Comment Letter B

- Conceptual Landscape Plans (Sheets 1 through 8 of 8)
- Plot Plan (Sheets 1 through 11 of 11)
- Tentative Parcel Map 38601 (Sheets 1 through 3 of 3)
- Preliminary Drainage Study report dated March 2024
- Copy of email response to Oscar Valadez dated January 22, 2024
- Response memo to our letter dated January 4, 2024
- Title Reports

Comment Letter B

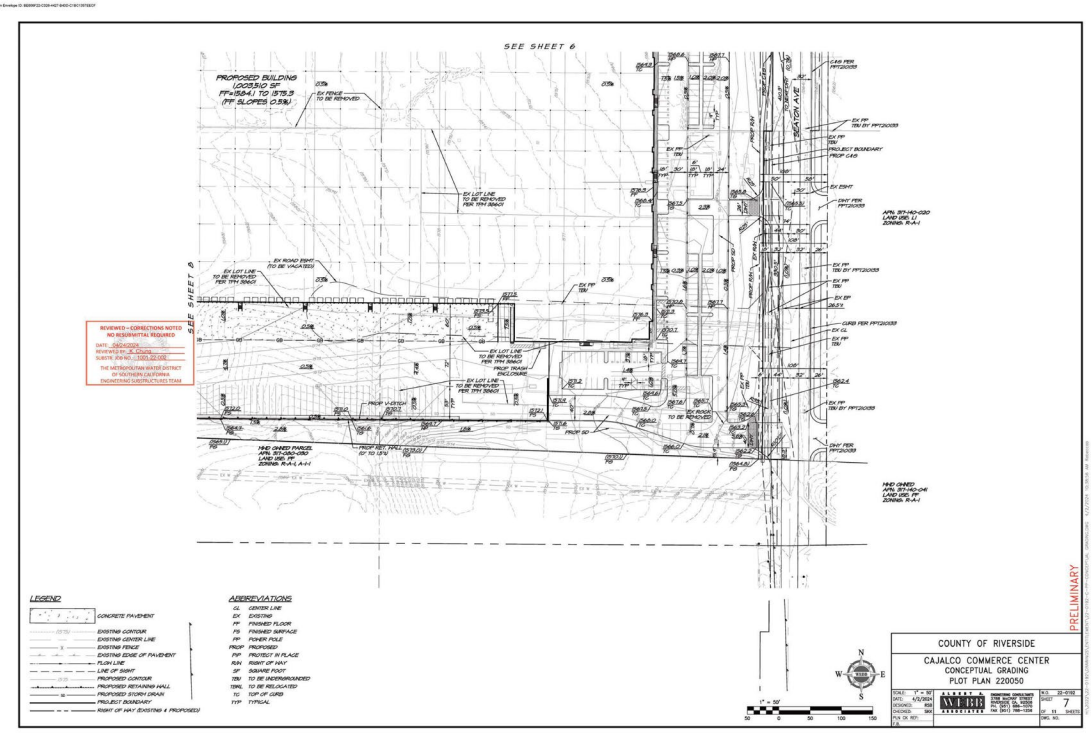
2. The location of the 16-foot-wide driveway approach on the easterly side of "Decker Road," as shown on Sheets 8 and 10 of 11 of your Plot Plans and on Sheets 1, 2, 7, and 8 of your Conceptual Landscape Plans, is acceptable to Metropolitan. However, we require that the same driveway approach be incorporated on the westerly side of "Decker Road" since the proposed curb and gutter on the westerly side will inhibit our ability to drive along our fee right-of-way.

3. We will allow the proposed catch basins on both sides of "Decker Road" within the limits of our fee property, as shown on Sheets 8 and 10 of 11 of your Plot Plans. However, we require that the catch basins, 24-inch storm drain line, sewer line, other non-potable utilities (if applicable), and laterals located within the limits of our fee right-of-way include secondary containment. The containment may consist of either a continuous steel sleeve or HDPE with fusion-welded joints. The catch basins can be wrapped with an impermeable liner. We note in your response that secondary containment will be addressed in the final engineering design.

MWD Comment 2: The location of the 16-foot-wide driveway approach on the easterly side of "Decker Road," as shown on Sheets 8 and IO of 11 of your Plot Plans and on Sheets 1, 2, 7, and 8 of your Conceptual Landscape Plans, is acceptable to Metropolitan. However, we require that the same driveway approach be incorporated on the westerly side of "Decker Road" since the proposed curb and gutter on the westerly side will inhibit our ability to drive along our fee right-of-way.

MWD Comment 3: We will allow the proposed catch basins on both sides of "Decker Road" within the limits of our fee property, as shown on Sheets 8 and 10 of 11 of your Plot Plans. However, we require that the catch basins, 24-inch storm drain line, sewer line, other non-potable utilities (if applicable), and laterals located within the limits of our fee right-of-way include secondary containment. The containment may consist of either a continuous steel sleeve or HDPE with fusion-welded joints. The catch basins can be wrapped with an
